ADDENDUM No. 1  
TO THE  
CONTRACT DOCUMENTS FOR CONSTRUCTION OF  
AIRPORT PARKING LOT IMPROVEMENTS  
PROJECT #20PW22

ISSUED THIS 5<sup>TH</sup> DAY OF FEBRUARY, 2021.

CITY OF ROSEBURG  
PUBLIC WORKS DEPARTMENT  
900 SE DOUGLAS AVENUE  
ROSEBURG, OREGON 97470  
(541) 492-6730

DESIGN:	RGC
	DRAWN:	RGC
	SCALE:	1"=10'
	SHEET:	3/7
DATE: 12/21/20		REVISIONS
		1. 1/4/21
		2.
		3.
		4.
AIRPORT PARKING LOT IMPROVEMENTS		20PW22
CITY OF ROSEBURG Public Works Department Brice Perkins, P.E. - DIRECTOR		GRADING PLAN

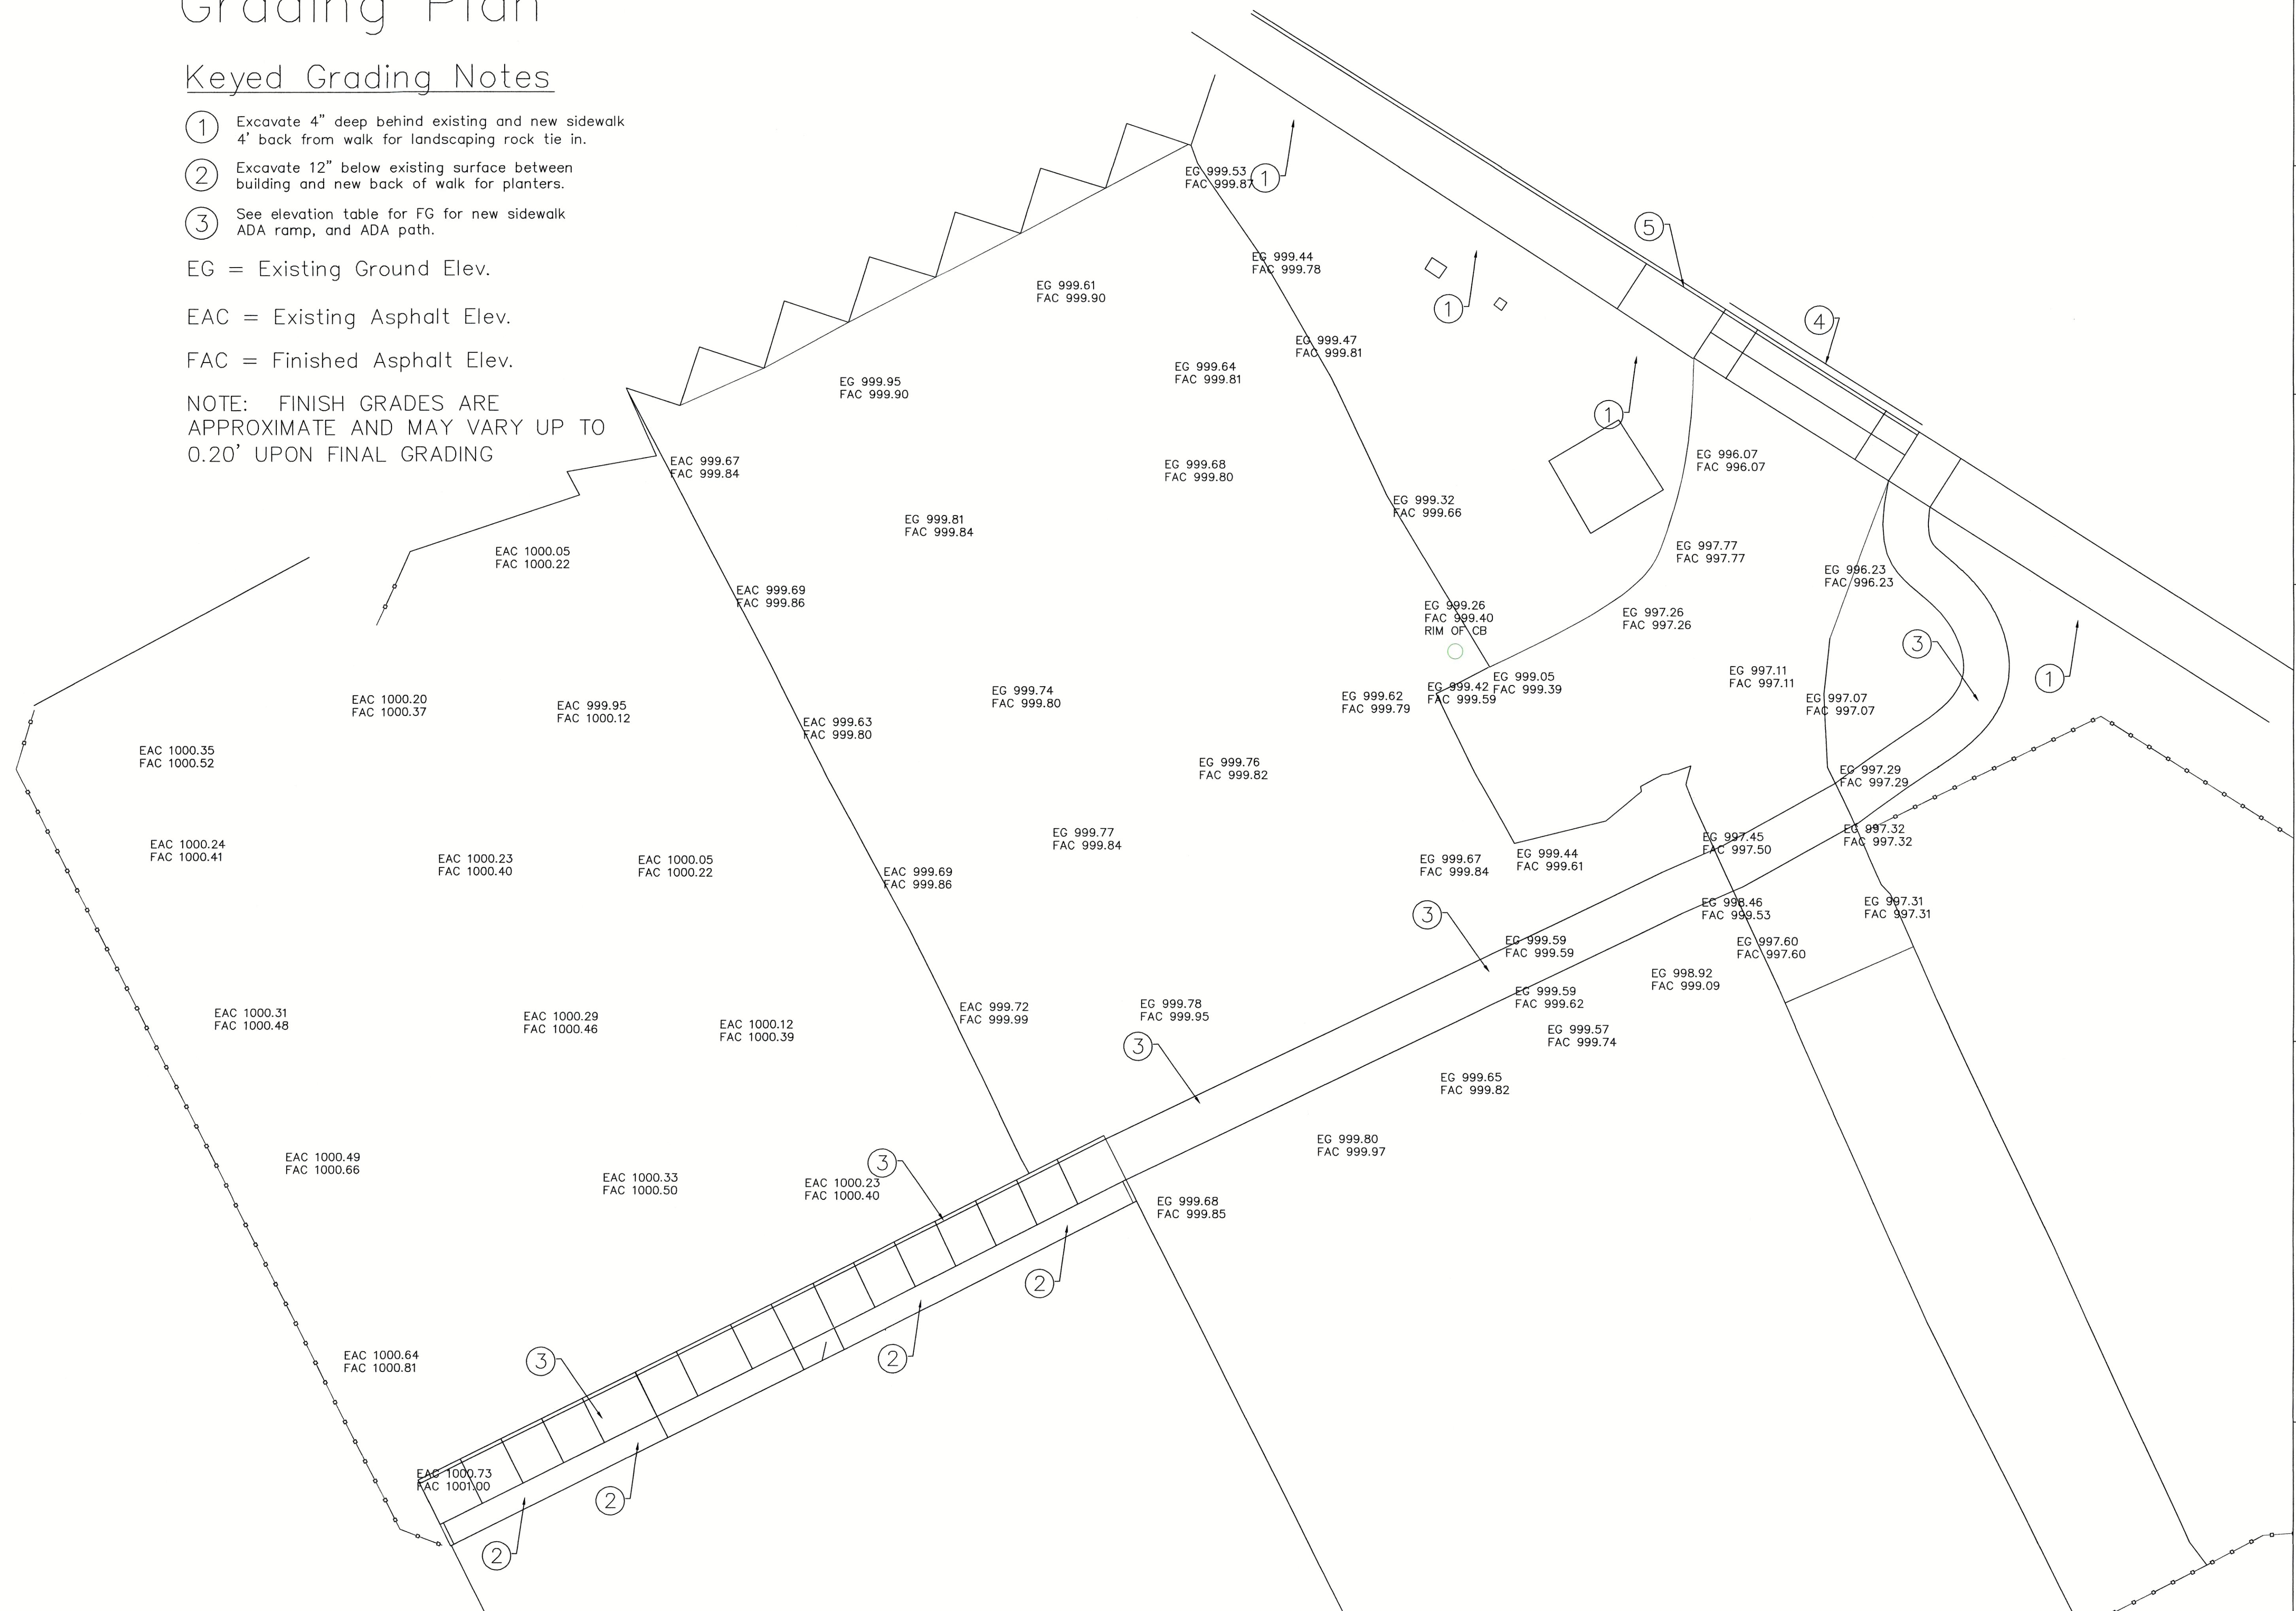
- a. There may be some import of agg base – see bid item #5 and general comment below. There will most likely be some export of existing aggregate in 4" asphalt section area – review sheet #3 Grading Plan.*

9. Under which bid item will the excavation in the areas shown on the landscape plan to receive rock be paid?

*a. There is no excavation shown on the landscape plan to receive rock. It is shown on note 1 on the grading plan (Sheet 3). Payment for excavation will be incidental.*

DATE: 12/21/20	DESIGN: RGC
	REVISIONS	DRAWN: RGC
	1. 1/4/21	SCALE: 1" = 20'
	2.	SHEET: 4/7
AIRPORT PARKING LOT IMPROVEMENTS 20PW22		SITE PLAN
CITY OF ROSEBURG Public Works Department Brice Perkins, P.E. — DIRECTOR

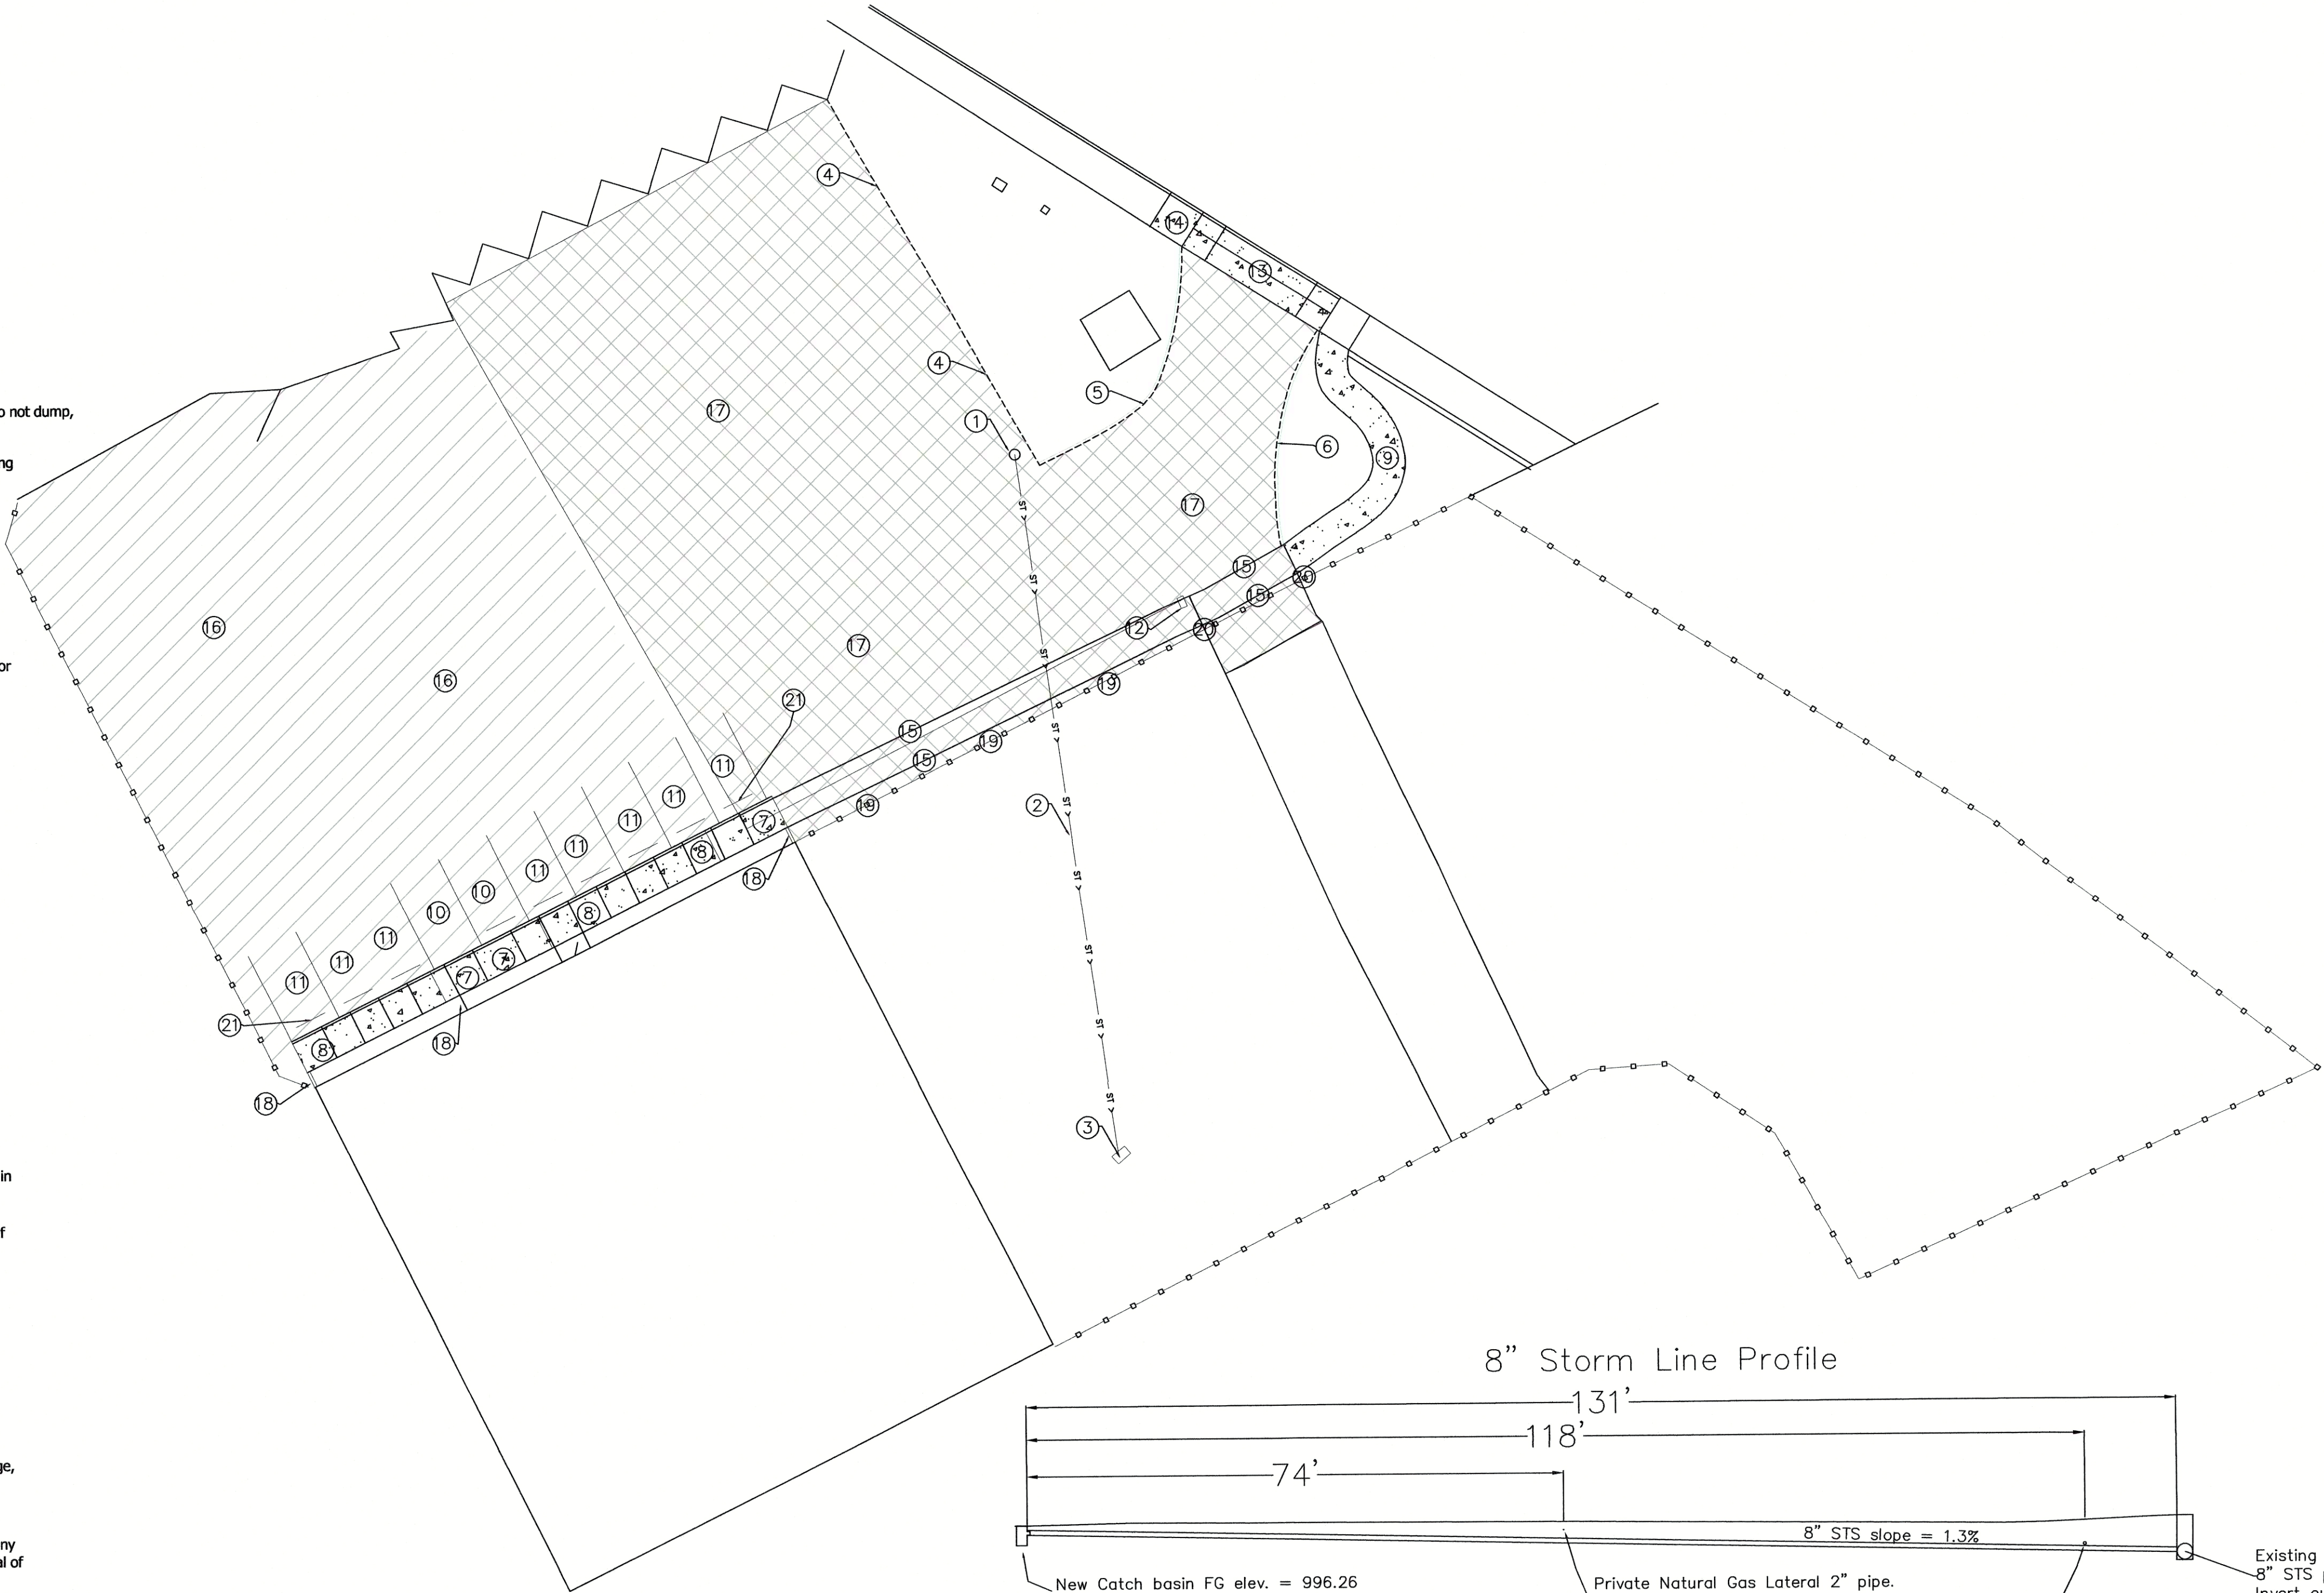
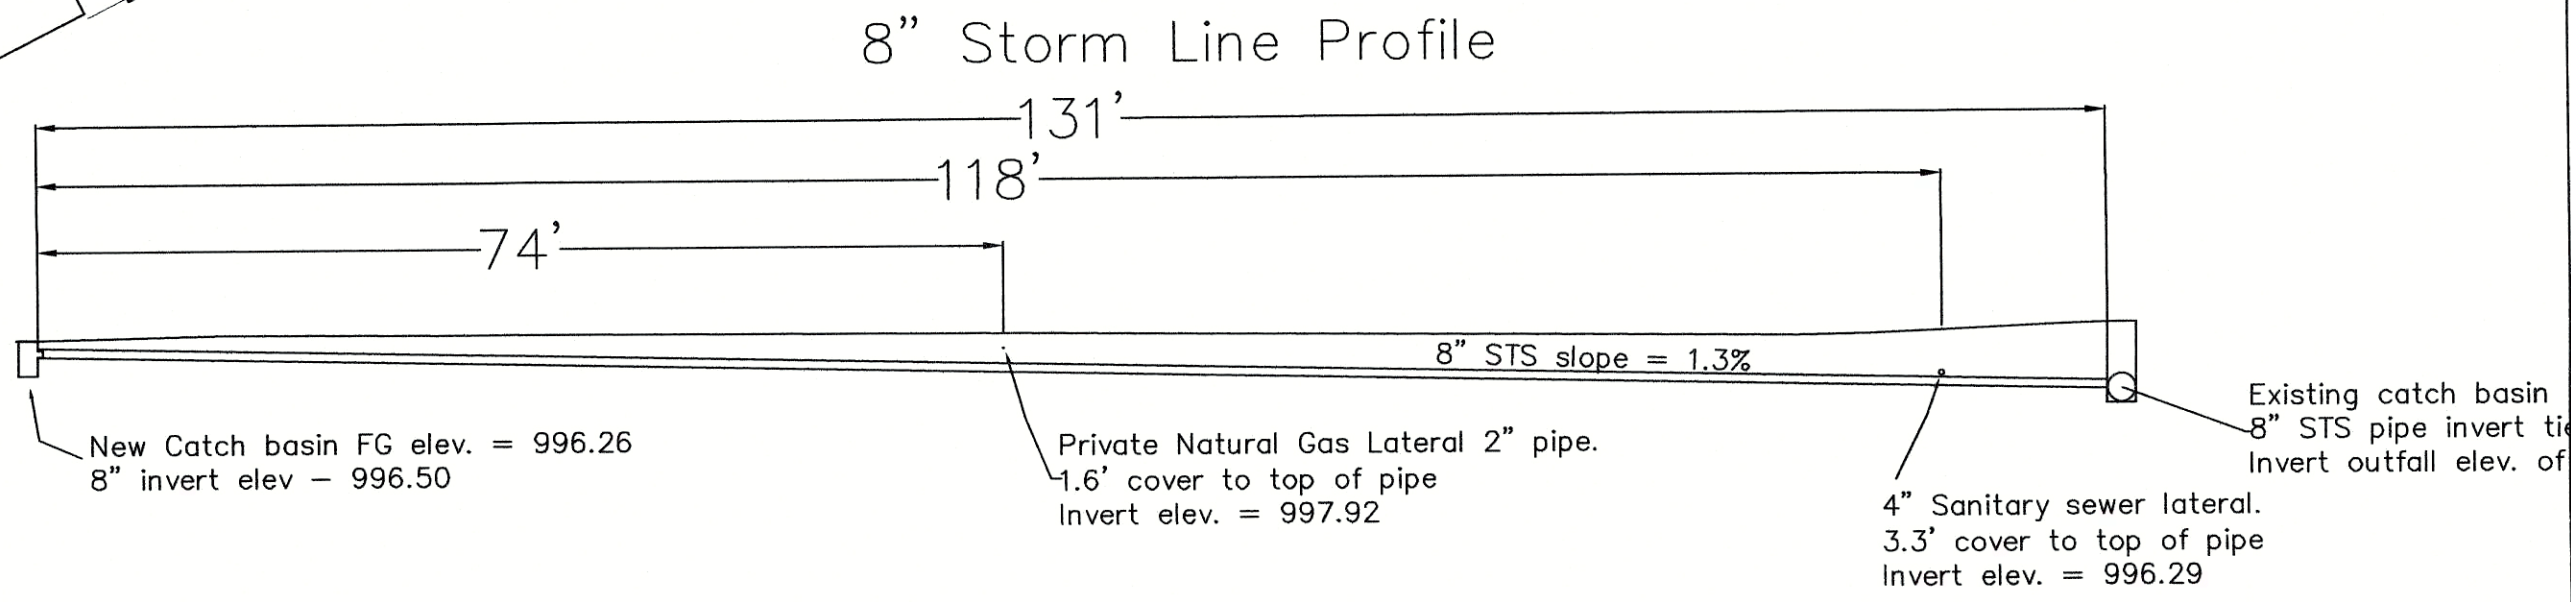
- a. Yes, all demo is incidental.*
4. There is no surface hatching under the alternate gate location but the sawcut is north of the gate. I am assuming this gets paved since the crosswalk paint goes through this area.

12. Where will the new fencing be install if that option is taken (note 19 on sheet 4 is missing from the plan view)?

15. Sheet 4/7 shows #8 on the right side of the page as mon curb and sidewalk. Looks like it should be 6' sidewalk #9

18. #18 shows 3 separate places for 12" stand curb and only 8 lf. I need more detail.

- a. Yes, this should be re-paved as the existing slope slightly exceeds the maximum 8.3% ramp run. See updated sheet #4.*
5. I am assuming it is your intent to not have any import or export associated with the 4" asphalt section area.

*a. Note 19 has been added to updated sheet #4.*

*a. This should be #9 and has been changed – see updated sheet #4.*

*a. There are three locations of the 12" standard curb that amount to 12 lf. Bid schedule and sheet have been updated.*

- Removed 10' of 6" curb from bid schedule and Sheet #4 – see note #5
- Added 4' of 12" standard curb to bid schedule.
- Added Aggregate base to the bid schedule. If needed, this is exclusively for fine grading of base rock of new asphalt parking area.
